# Administrative Approval Action

Case File / Name: SUB-0045-2019  
Lots 5, 6, & 7 Cartier Subdivision

**REQUEST:** Development of a 0.68 acre/29,827 sf tract zoned R-6 with .05ac/2,214 sf of right-of-way dedication for a net area of .63 ac/27,613 sf. An existing 3 detached single-family residential lots being recombined and subdivided, adding 1 additional residential lot, for a proposed 4 single-family detached residential lot subdivision. Existing Lot 5 being .14ac/6,073 sf; Lot 6 -.15ac/6,481sf; Lot 7-B -.20ac/8,896 sf and new Lot 201 being .14 ac/6,164 sf.

PRELIMINARY SUBDIVISION  
PLANS  
SUB-0045-2019

SUBDIVISION & UTILITY PLAN

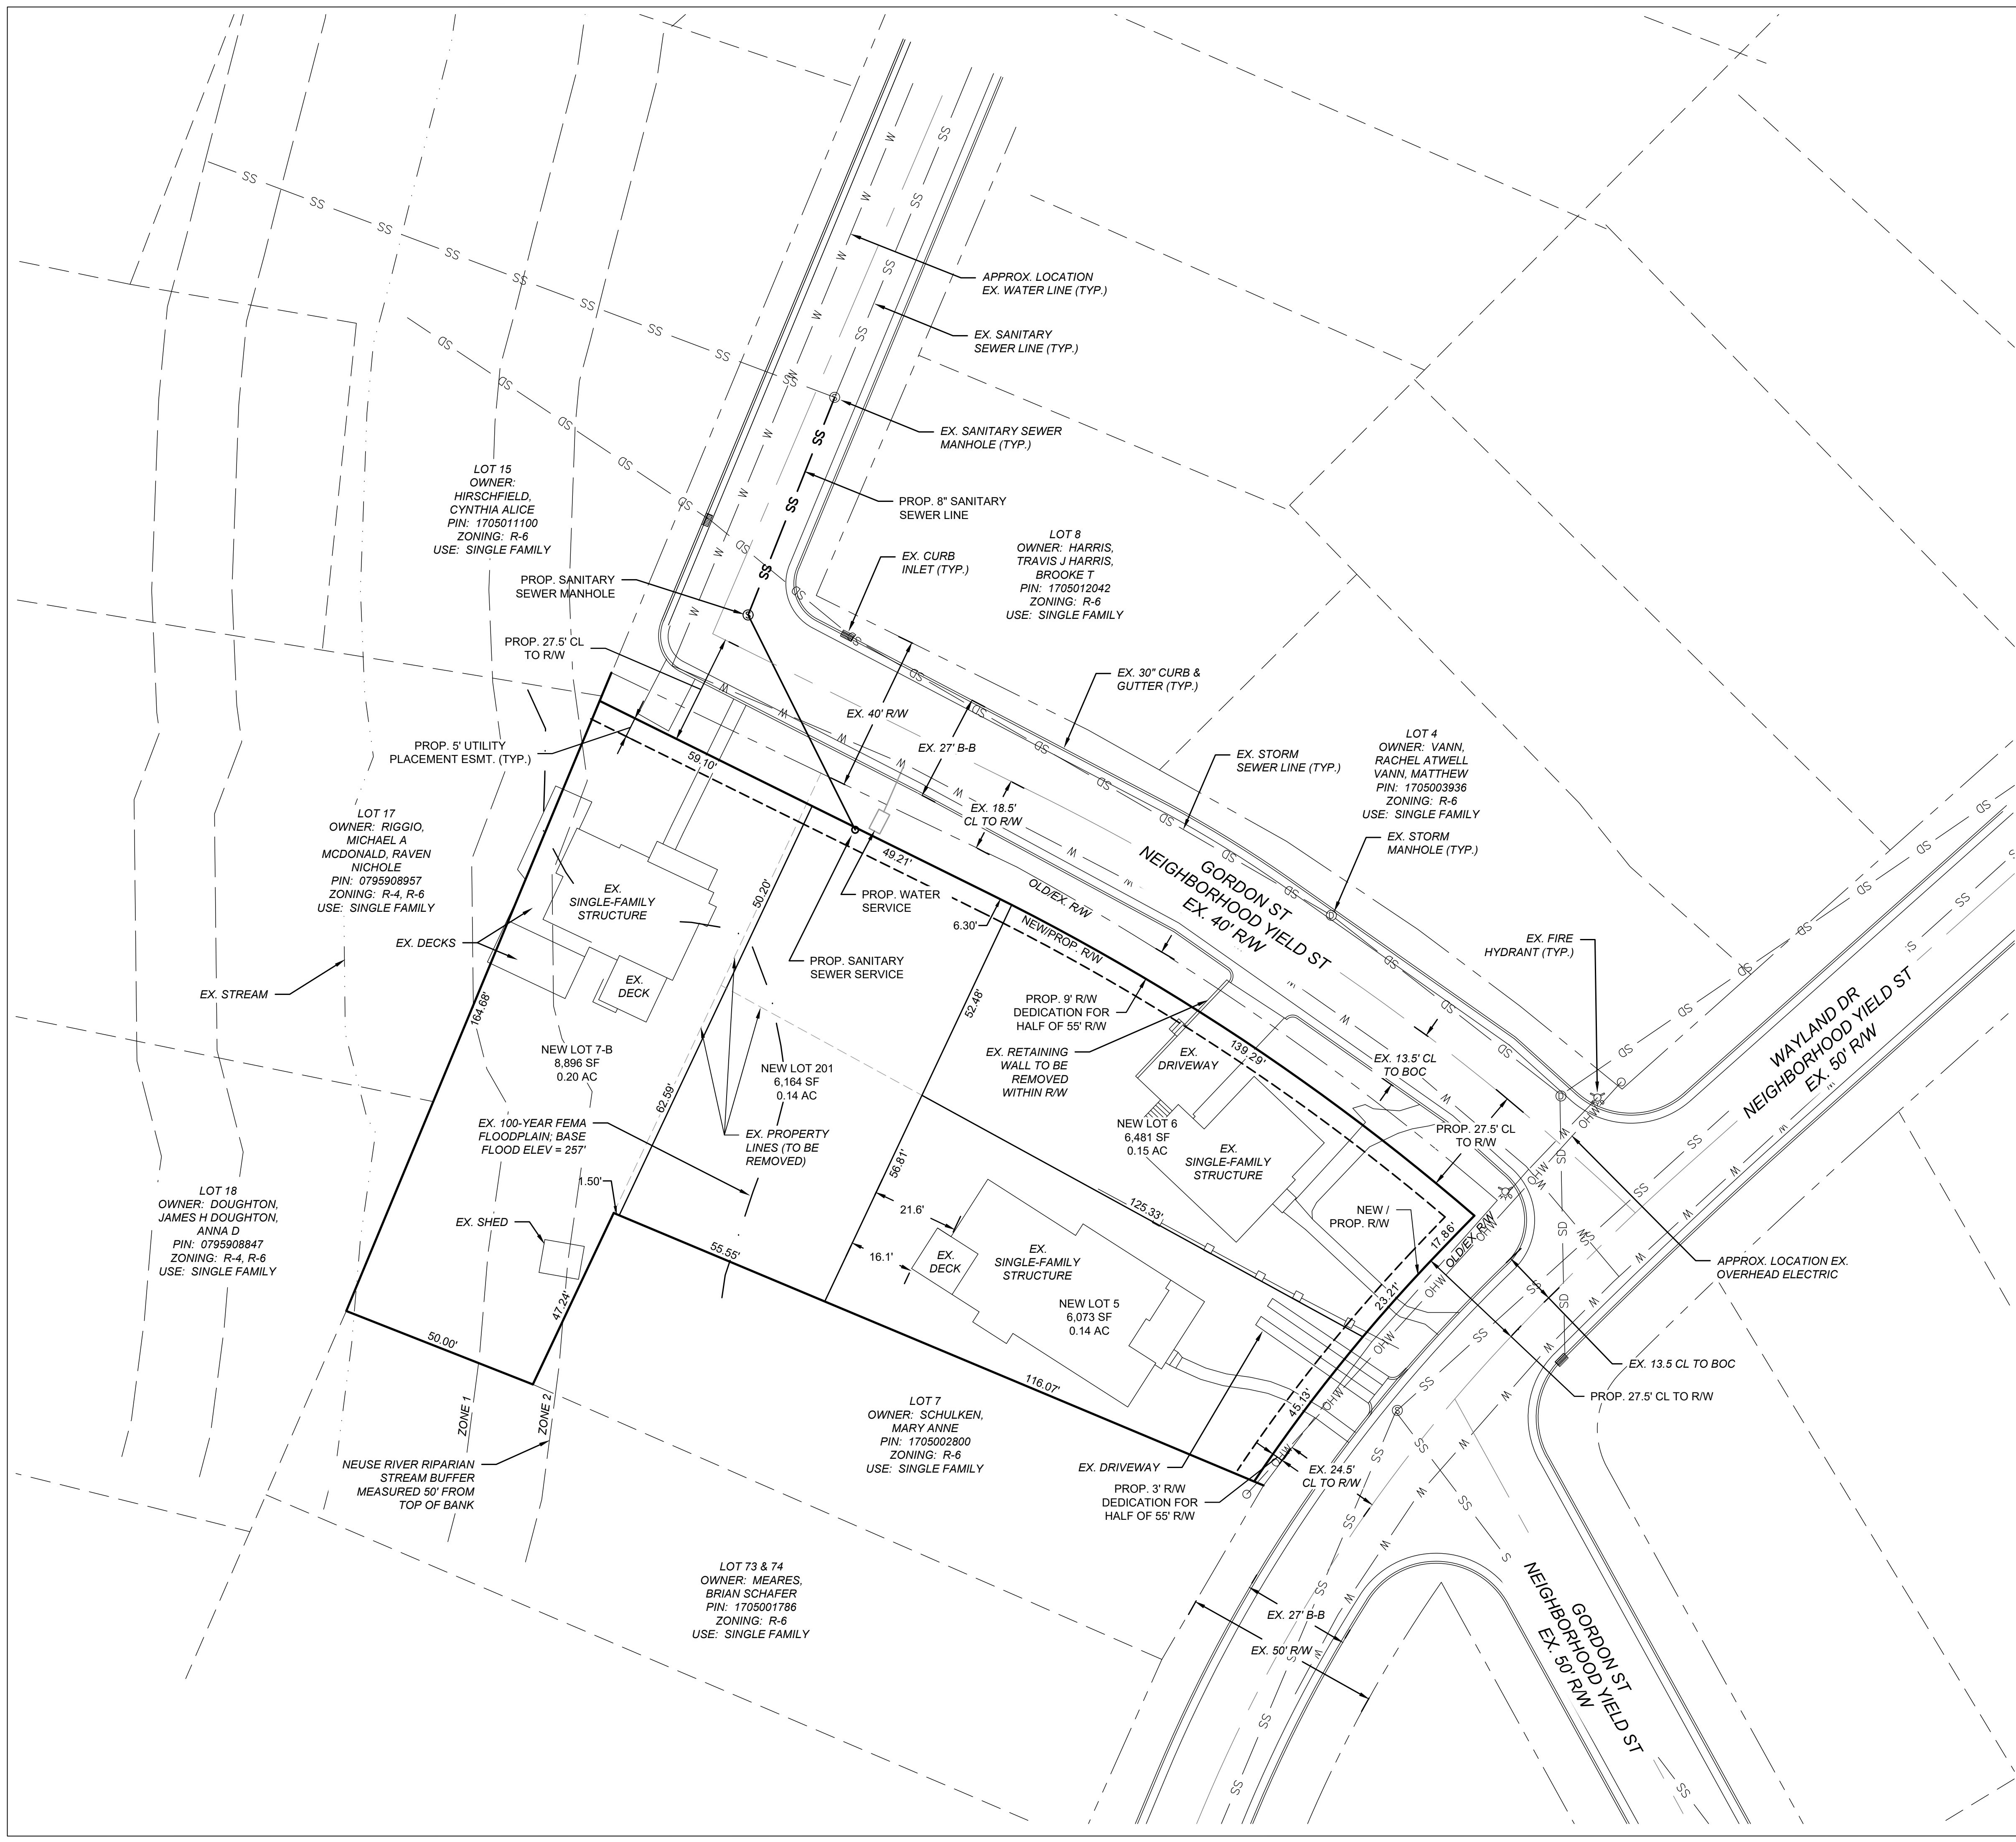
1. A recombination plat is recorded in conjunction or prior to the recording of the subdivision lots for the approved subdivision plan.
2. The side yard lot line setbacks are dimensioned & labeled on all plat recordings, for Lot 7-B per the preliminary subdivision plan sheet, demonstrating compliance with UDO Sec.2.2.1.

## LANDSCAPE PLAN

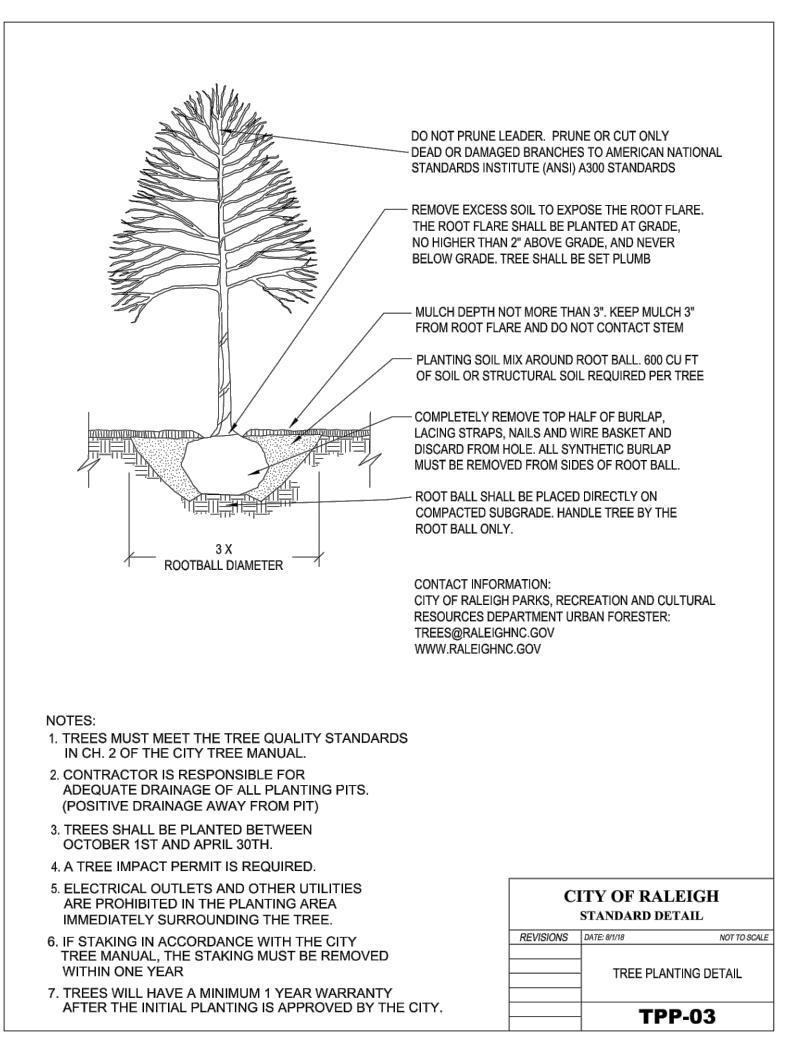
4. A tree impact permit must be obtained for the approved streetscape tree installation in the right of way. This development proposes 4 street trees along Gordon St, and 2 street trees along Wayland St. All required street tree plantings are required to be planted and inspected with building permit for Lot 201.
